Access Compliance Report

Public Rights-of-Way

(Curb Ramps)

Intersection ID: 10039181	Main Street: SUMNER_HALL_LN	Cross Street: N/A	Location: S
ADA ID: C26827A2A75D	Ramp Type: PerpDiag	Initial Pass/Fail: Fail	Overall Compliance: No
Severity Score: 33.75			
Codes/Mitigation Info/Possible Solution		Field Measurements/Component Compliance

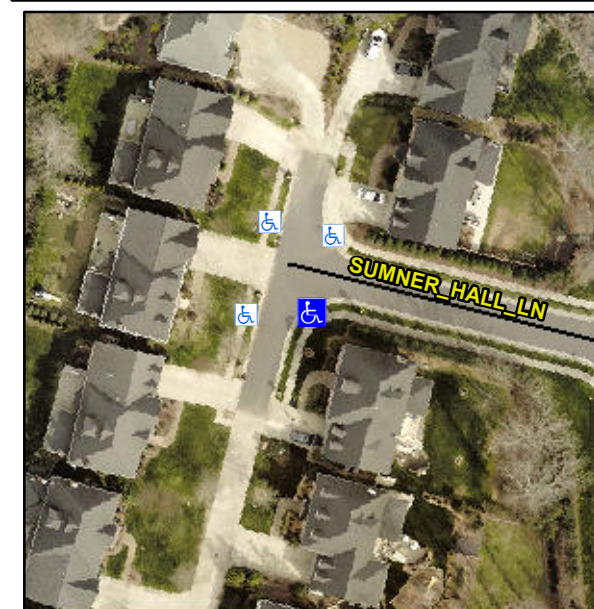
Not Found, R304.5.1, R304.2.2

Remove & Replace Curb Ramp With Two New Directional Ramps or Equivalent.
